2016 Safety Package FOR GT Seat

From January 2016, according to the latest FIA requirements, for all seats 8862/2009 approved

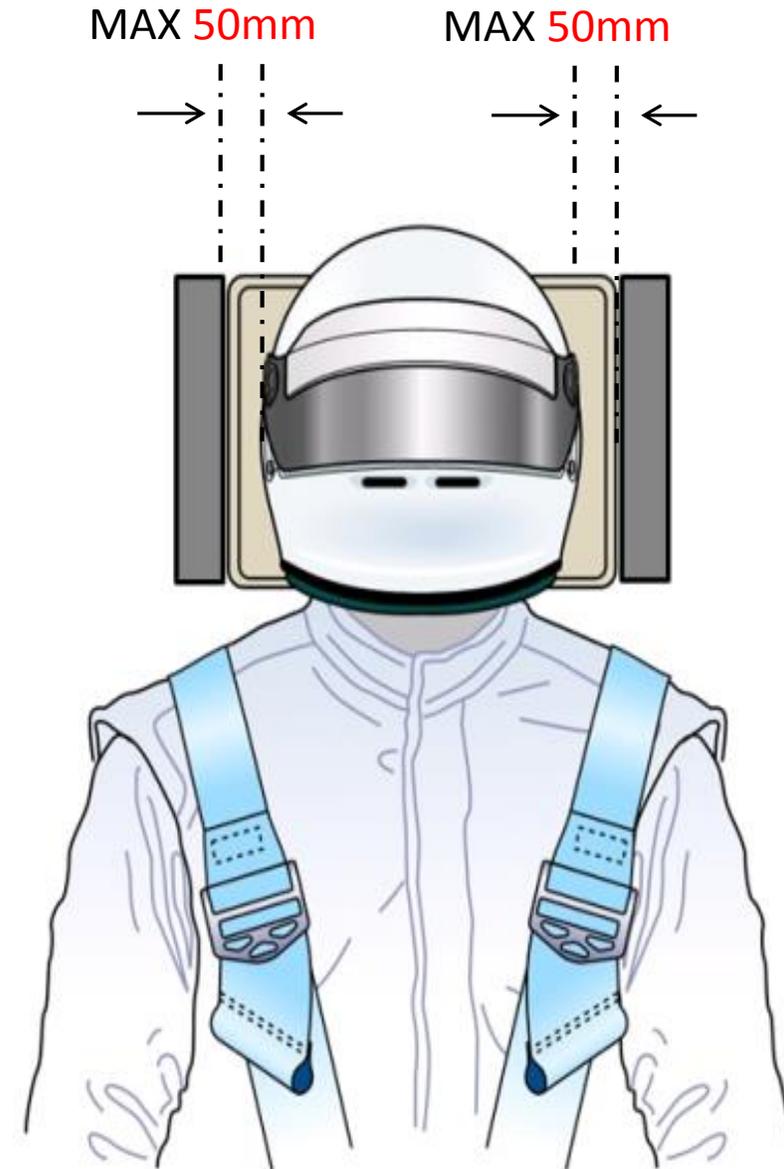
the maximum distance between the driver's helmet and the seat headrest must not exceed 50 mm on either side.

Provided with additional foam to meet the new distance established by the new FIA standard.

Addition of FIA-approved side cushions to reduce the distance to 50 mm, with Velcro fastening (to be ordered separately).

Cushions part number: **MS350878NR**
